APPLICATION NO.	FILING DATE	FIRST NAMED INVENTOR	ATTORNEY DOCKET NO.	CONFIRMATION NO.
10/567,121	02/03/2006	Kenta Hatano	1163-0543PUS1	3023

Office Action Summary	Application No. 10/567,121	Applicant(s) HATANO ET AL.	
	Examiner NAISHADH N. DESAI	Art Unit 2834

DETAILED ACTION

FIG. 4A

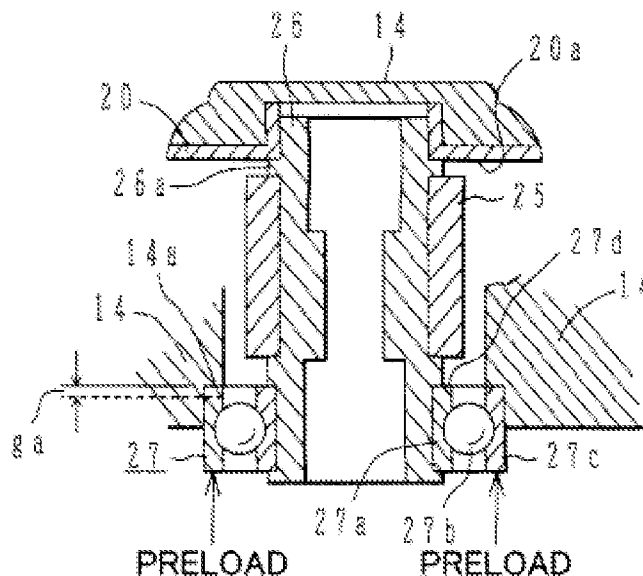
A motor-bearing holding structure comprising (Figs 4A&B):

a first bearing (Fig 4A,27) having an inner wheel (Fig 4A,27a) and an external wheel (Fig 4A,27c),

4. Regarding claim 7, Watanabe et al teaches a second bearing (Fig 4B,102,103) wherein the molded rotor (method of making, patentable weight not given) is rotatably and axially movable over a predefined range held by the first and second bearings (it is obvious that the washer (Fig 1,28) will allow movement of the bearings in the axial direction).

FIG.1

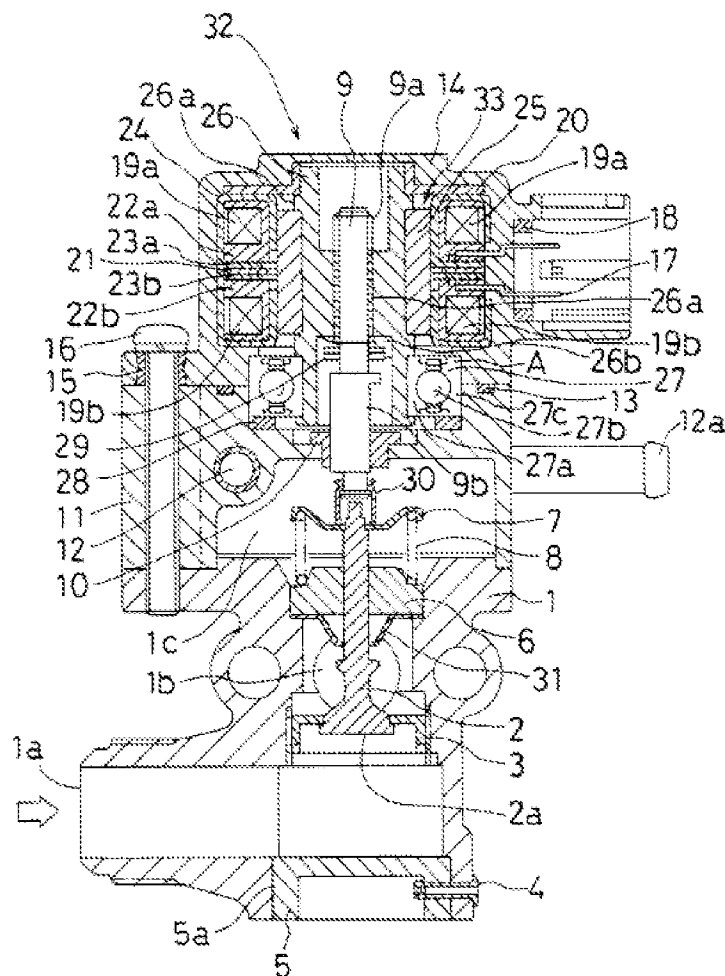
a metallic member (Fig 1,28) having a first end portion and a second end portion, wherein the first end portion (it is clear that element 28 in Fig 1 has a first and second end portion) is integrally molded with the rotor (method of making limitation, patentable weight not given); and

2. Regarding claim 3, Watanabe et al teaches (Fig 1,28) a washer that is fitted to the external wheel of the metallic member protruding from the rotor is secured to the metallic member under conditions where the washer is pressed against the bearing. Also Ohta et al (Fig 1,51) teaches the use of a plate spring which directly abuts the bearing.

7. Regarding claim 14, Watanabe et al teaches that the metallic member is a ring-shape metallic member (Fig 1,28).

FIG. 1

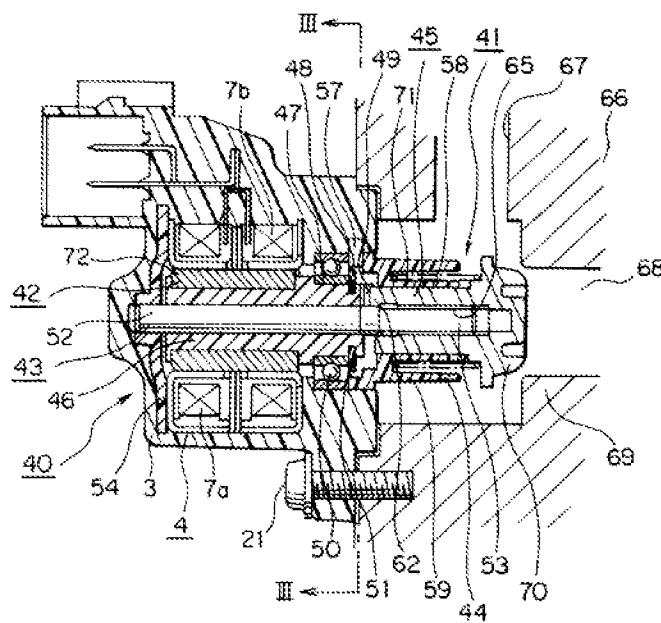
Ohta et al teaches a device having a metallic member (Fig 1,51 and Col 5 ll 55-56) wherein the second end portion of the metallic member (Fig 7,51) is rotatably held to the inner wheel (Fig 1 by element 47 indicating inner race / wheel of bearing) at two or more places at equally spaced intervals around a rotary central axis of the molded rotor (Figs 7 and 8 element 51).

6. Regarding claim 13, Ohta et al teaches that the external diameter of the washer (Figs 7 and 8,51) is superimposed on the inner wheel (Fig 1,51) so the washer can be pressed to be abutted against the inner wheel with a uniform force.

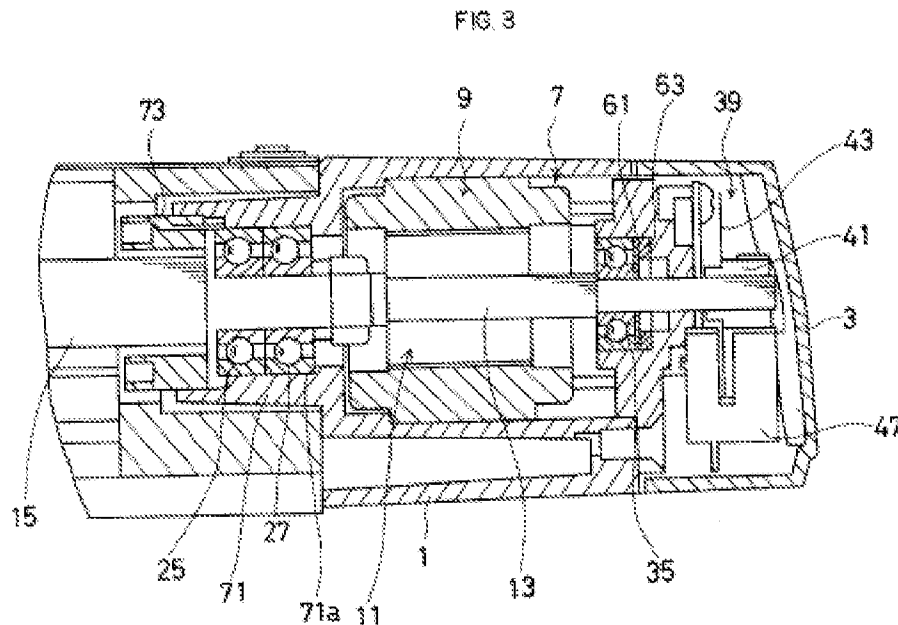
3. Regarding claim 4, Ohta et al teaches (Figs 7 and 8) that the molded part of the metallic member is provided with a concave portion.
